**PLEASANT PRAIRIE PLAN COMMISSION MEETING  
VILLAGE HALL AUDITORIUM  
9915 39<sup>th</sup> AVENUE  
PLEASANT PRAIRIE, WISCONSIN  
6:00 P.M.  
AUGUST 22, 2016**

Consider the request of John Doheny, agent for approval of **Preliminary Site and Operational Plans** for the mass grading, installation of underground utilities and footings and foundations for the construction of a 175,000 square foot industrial building on the vacant land located on the southeast corner of STH 165 (104<sup>th</sup> Street) and 80<sup>th</sup> Avenue in LakeView Corporate Park.

TO: Peggy Herrick, Assistant Planner / Assistant Zoning Administrator  
FROM: John Steinbrink, Jr., P.E., Director of Public Works  
CC: Matthew Fineour, P.E., Village Engineer  
Jean Werbie-Harris, Community Development Director  
SUBJ: **DEV1607-002 DOHENY PRE SITE AND OP**  
DATE: August 1, 2016

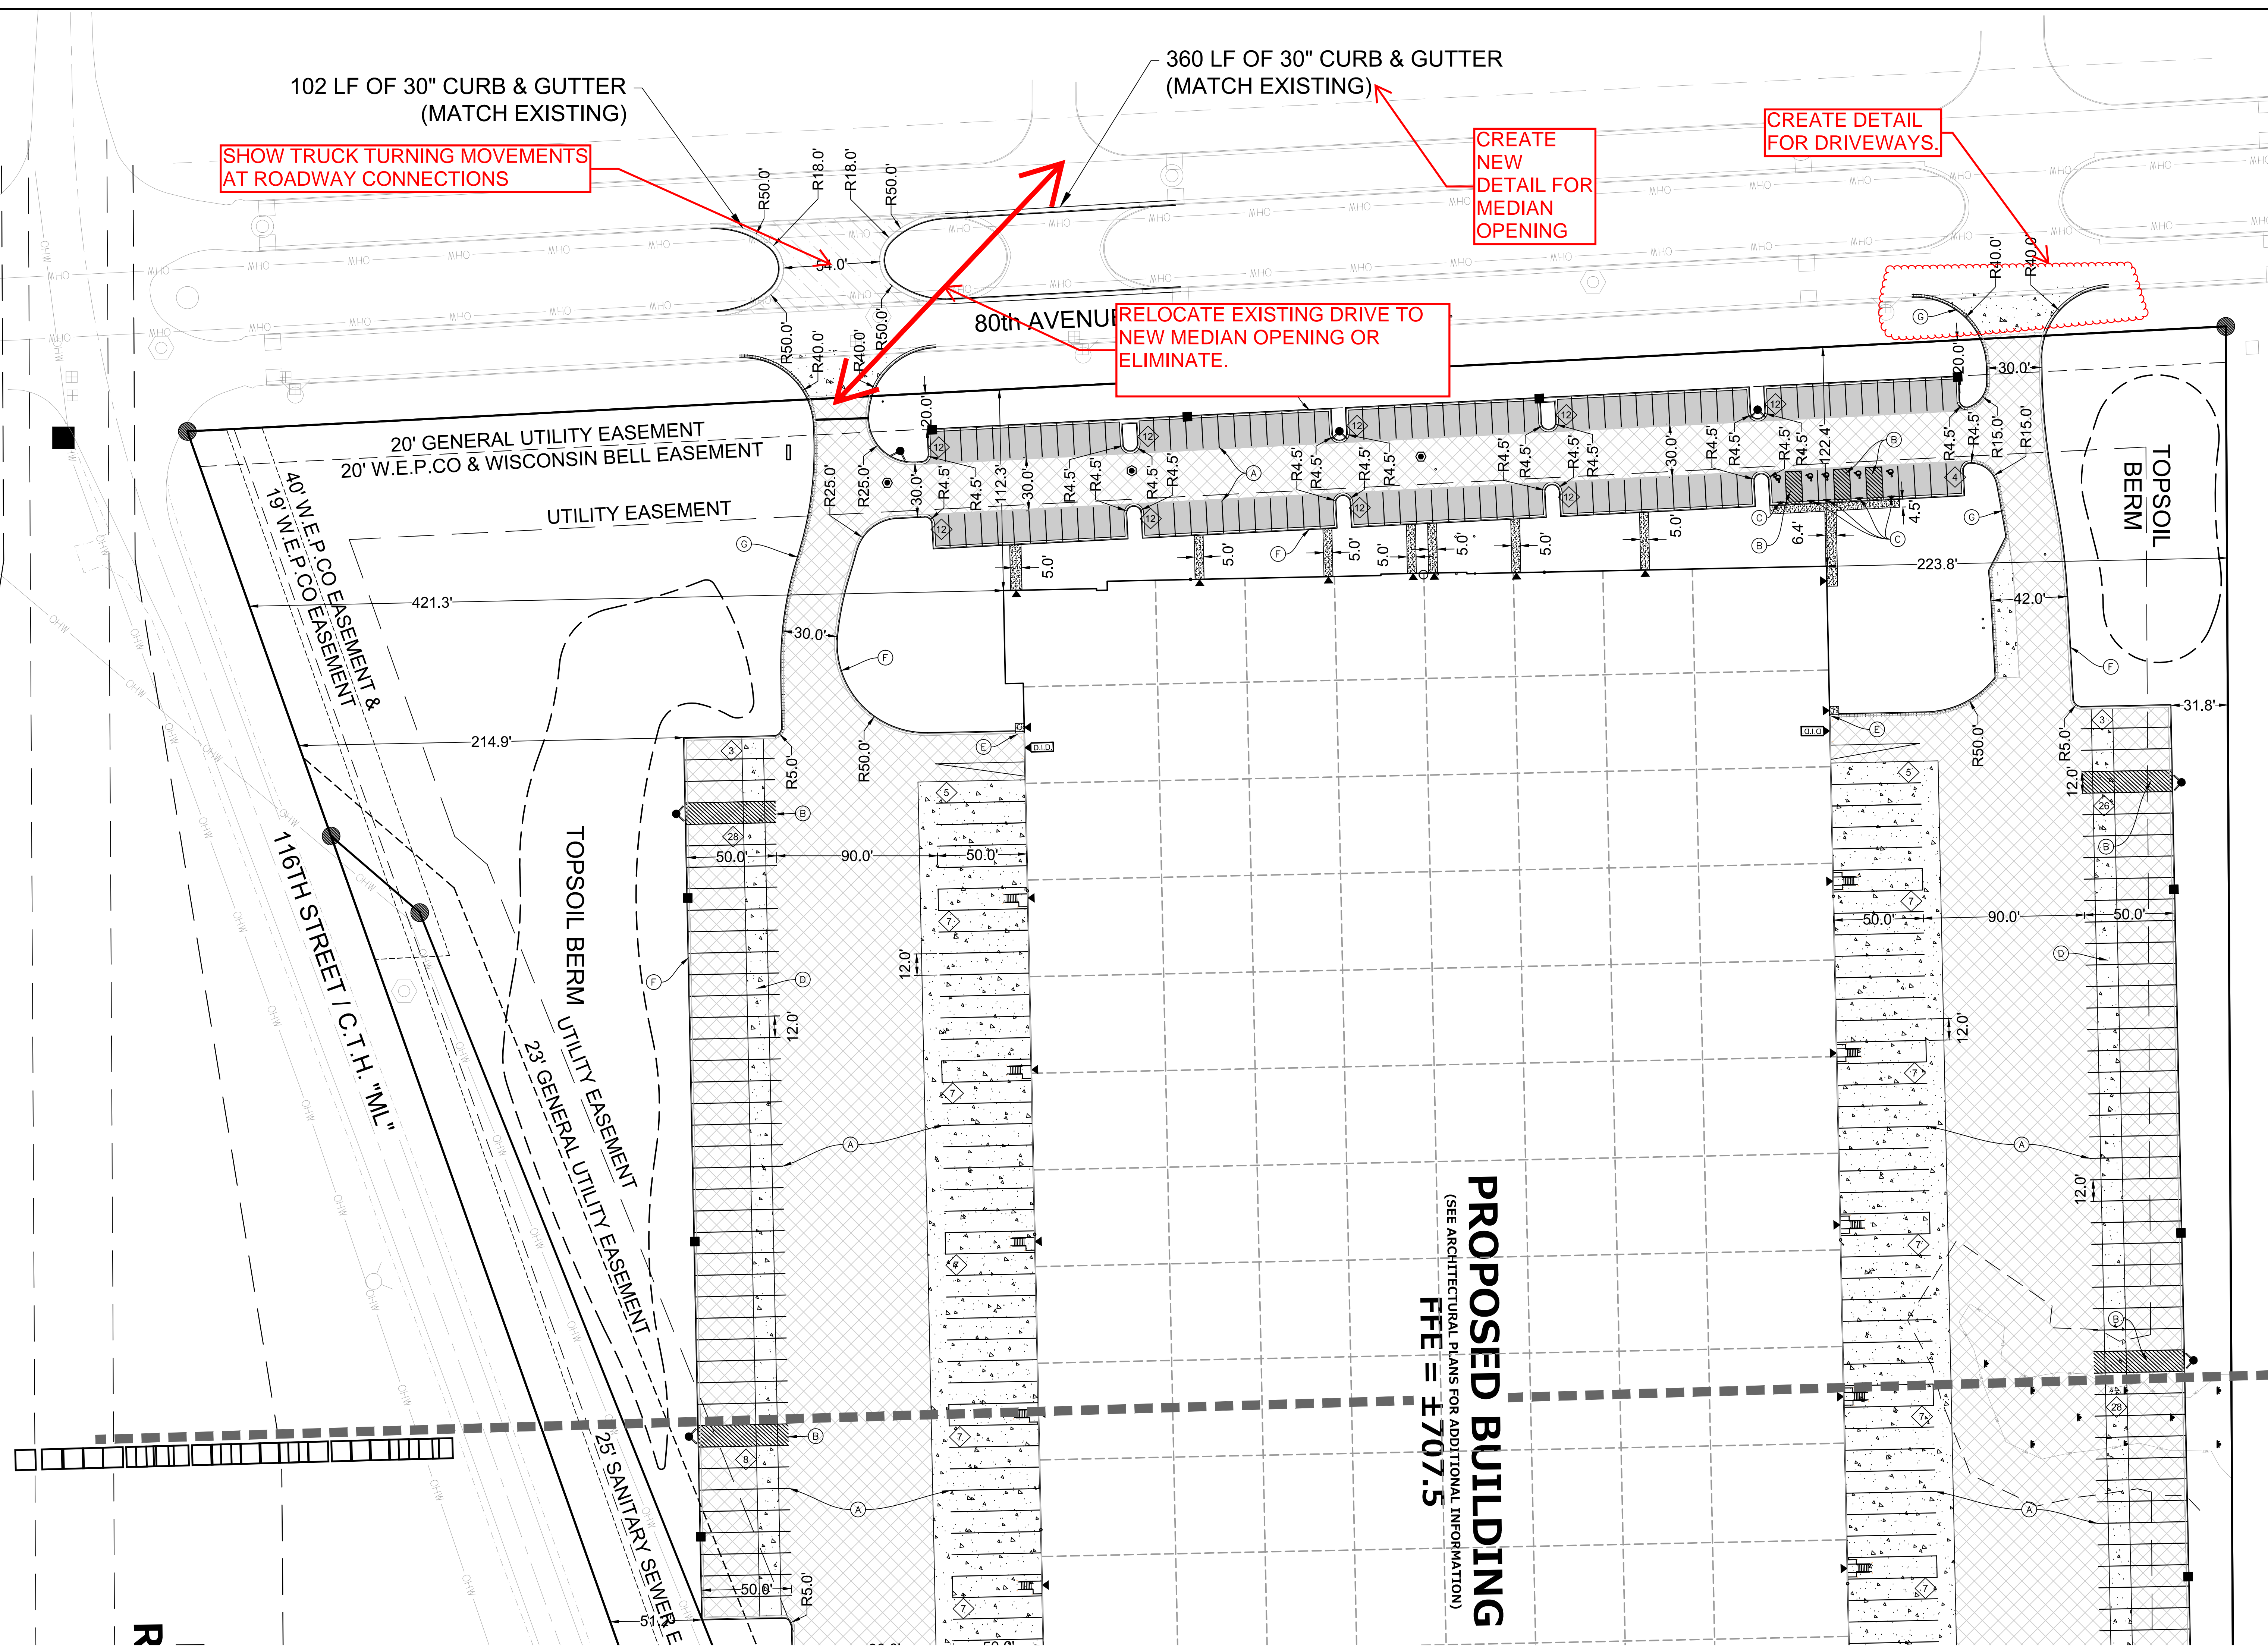
SHOW TRUCK TURNING MOVEMENTS  
AT ROADWAY CONNECTIONS

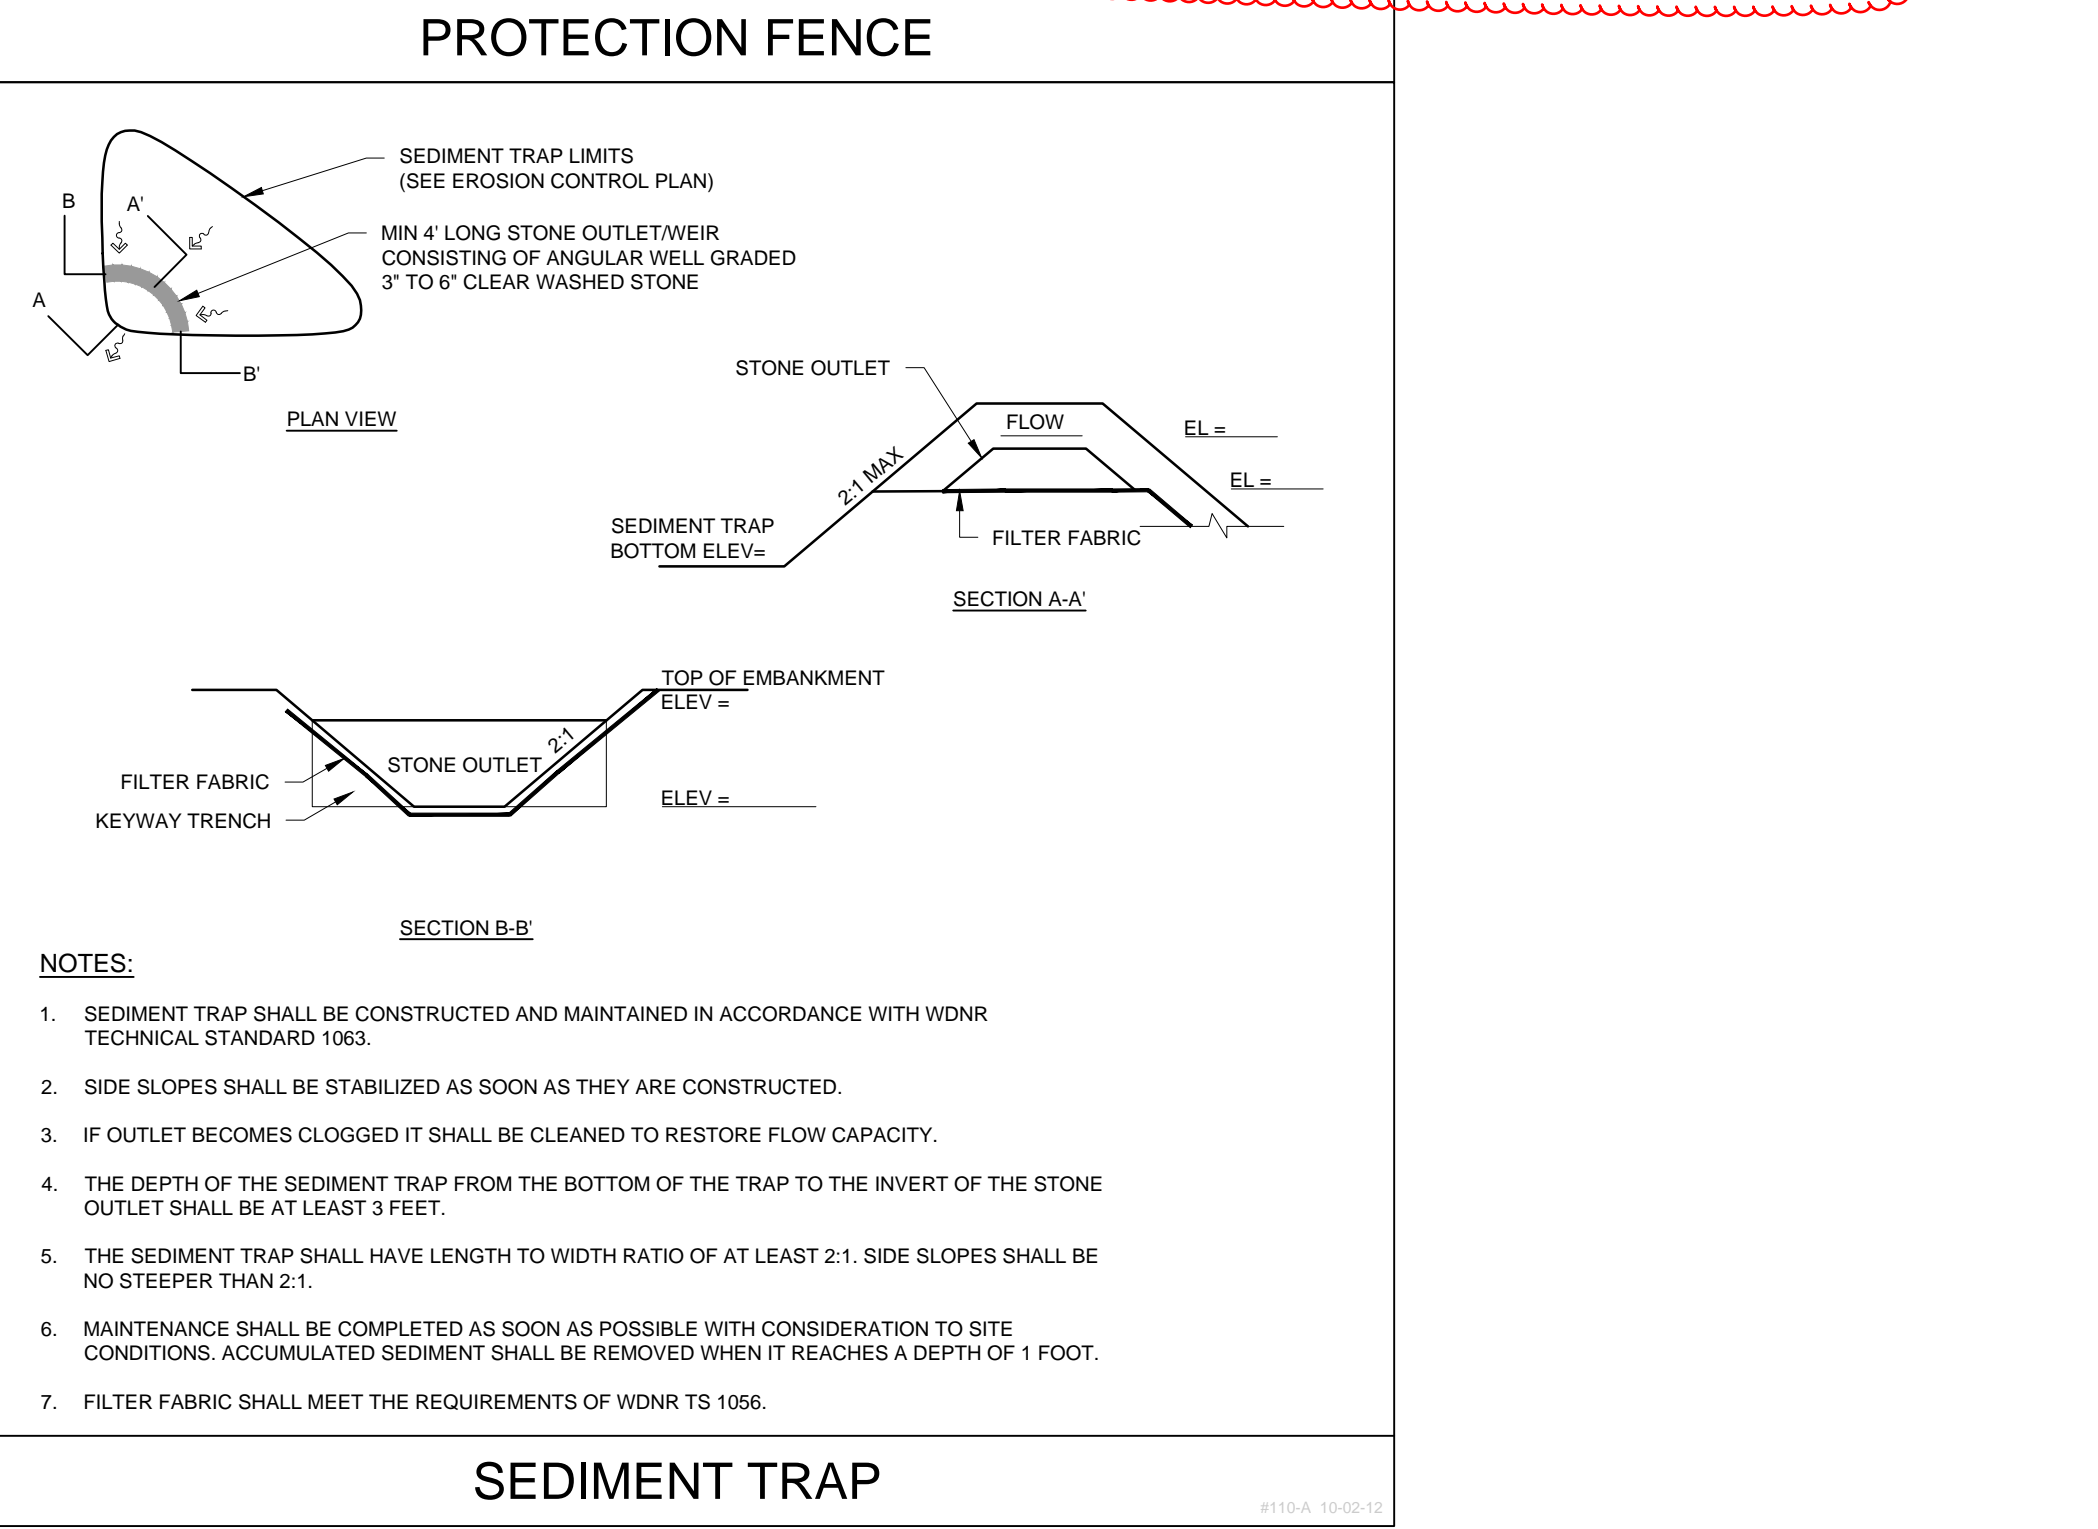
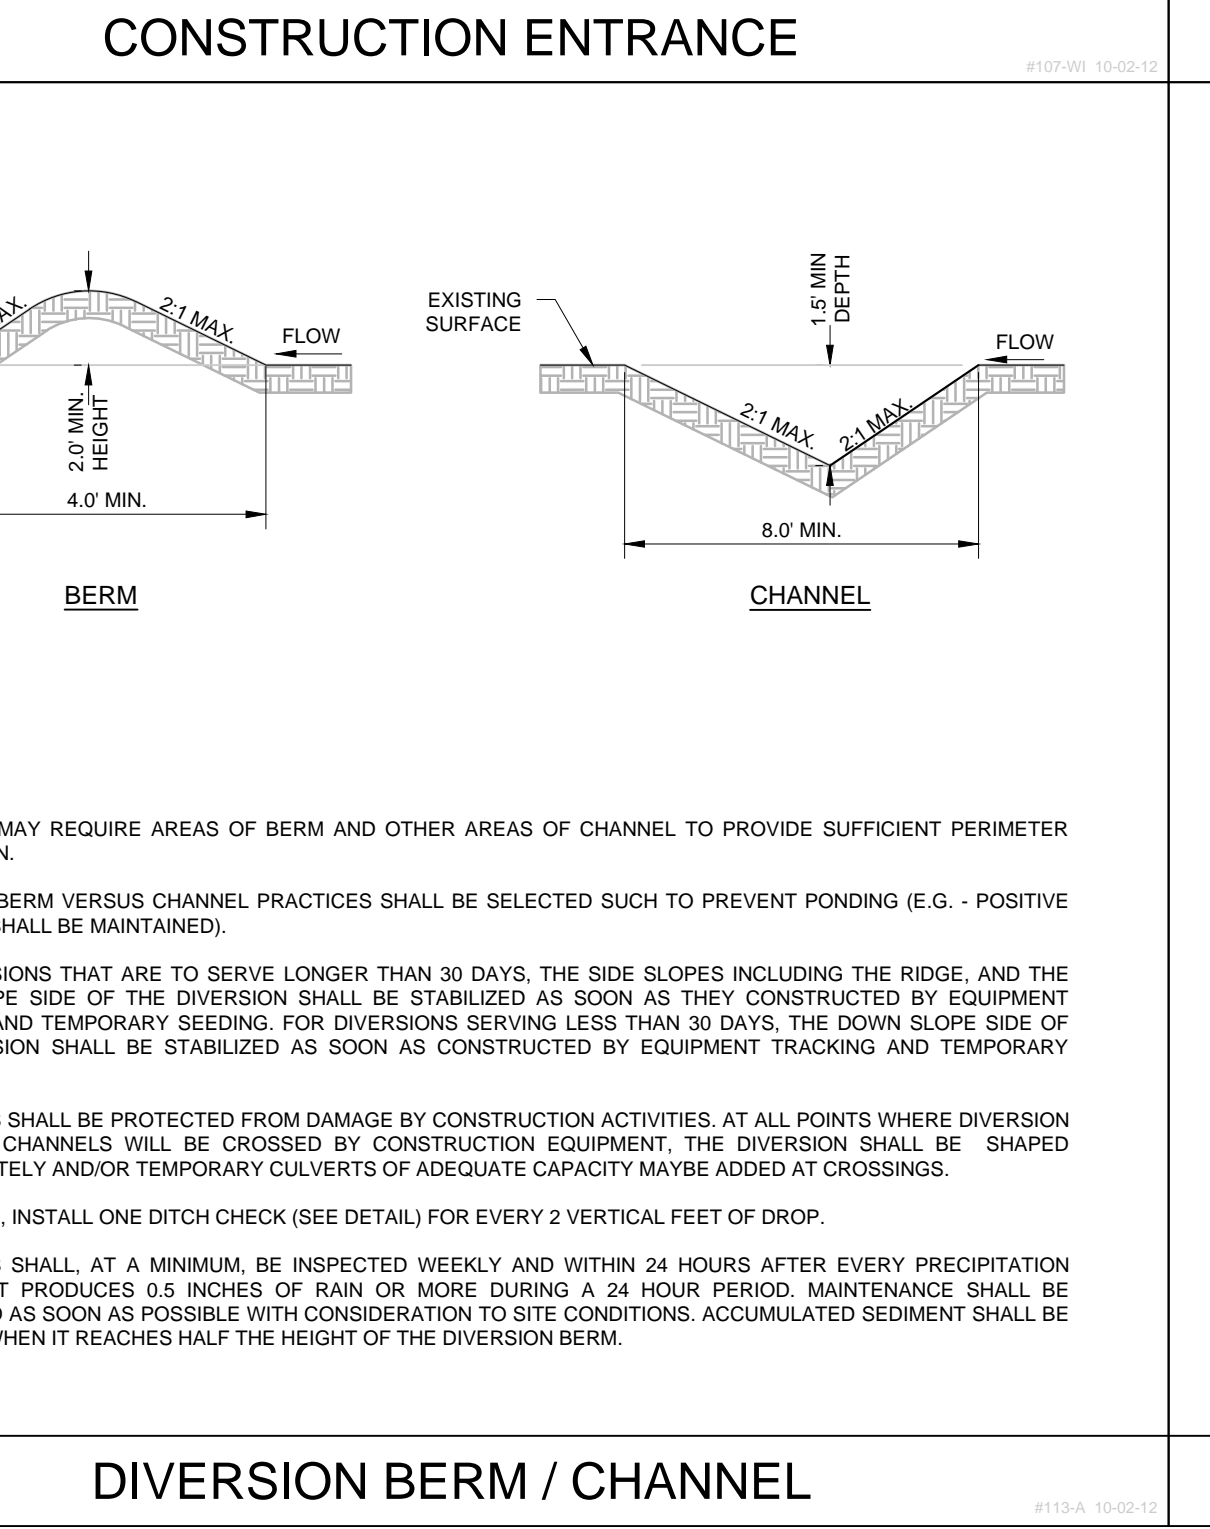
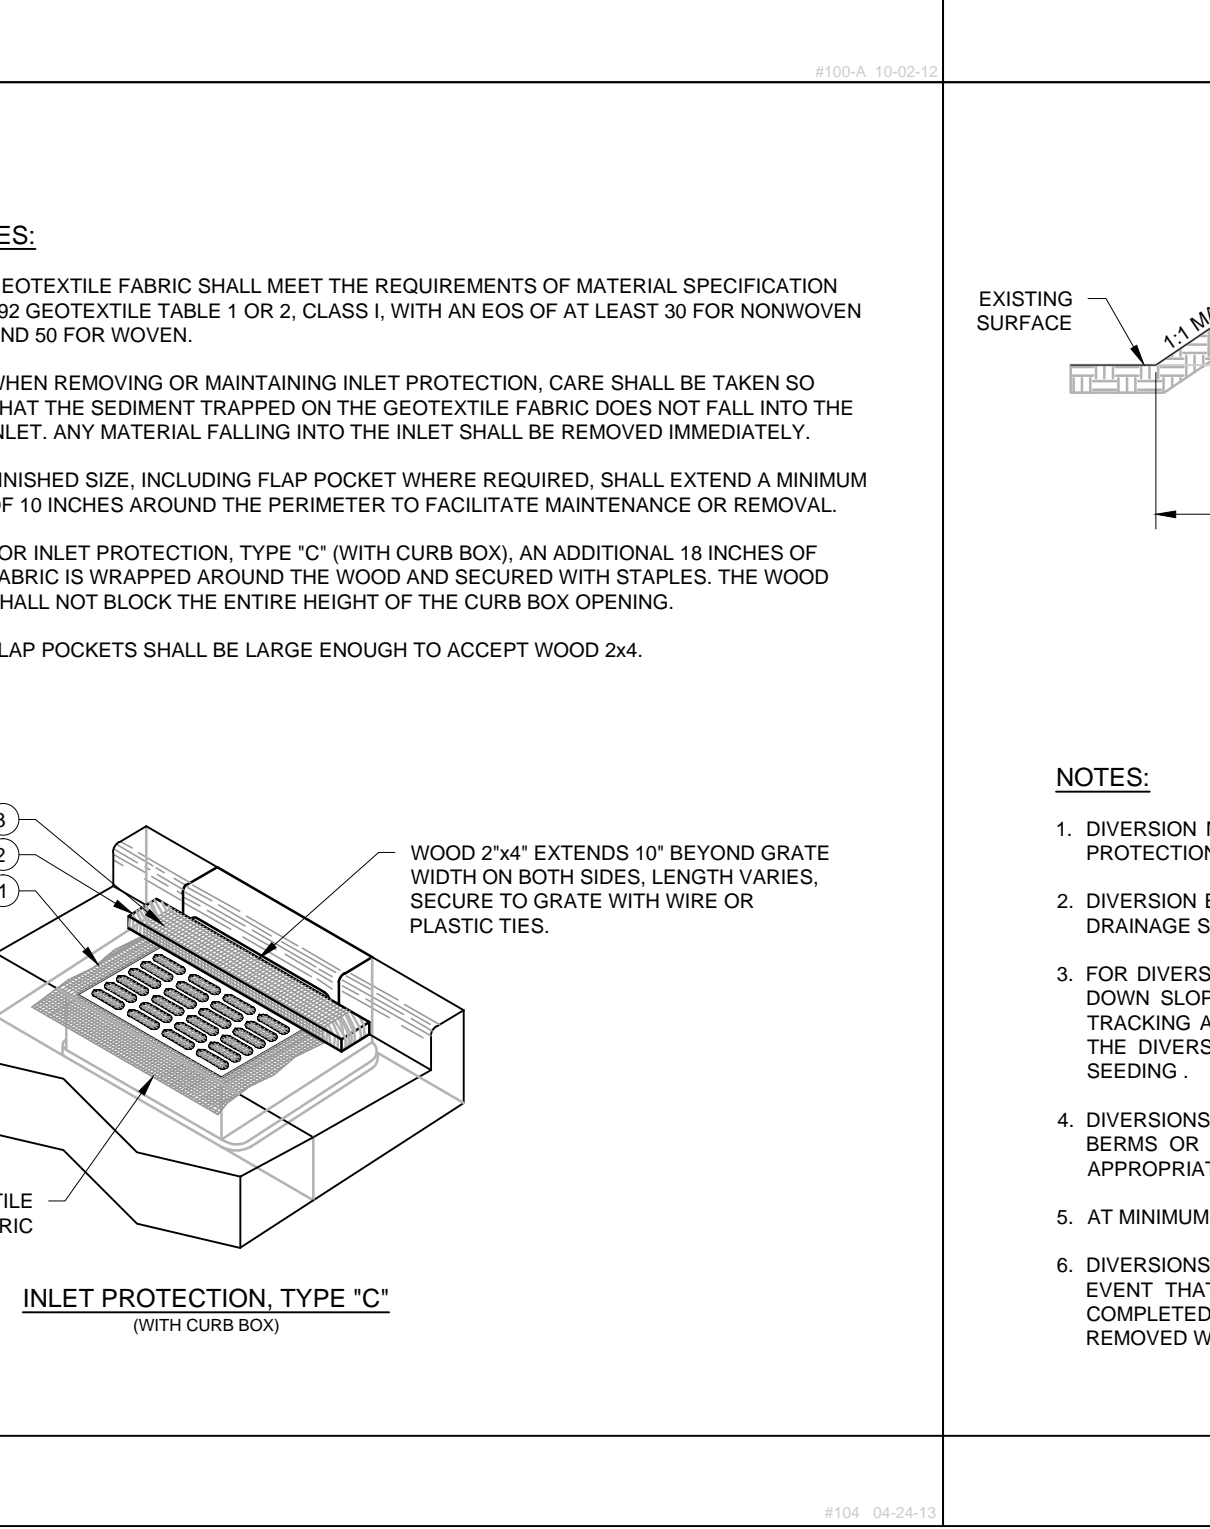
SHOW AND LABEL LOCATION ON THE PLANS
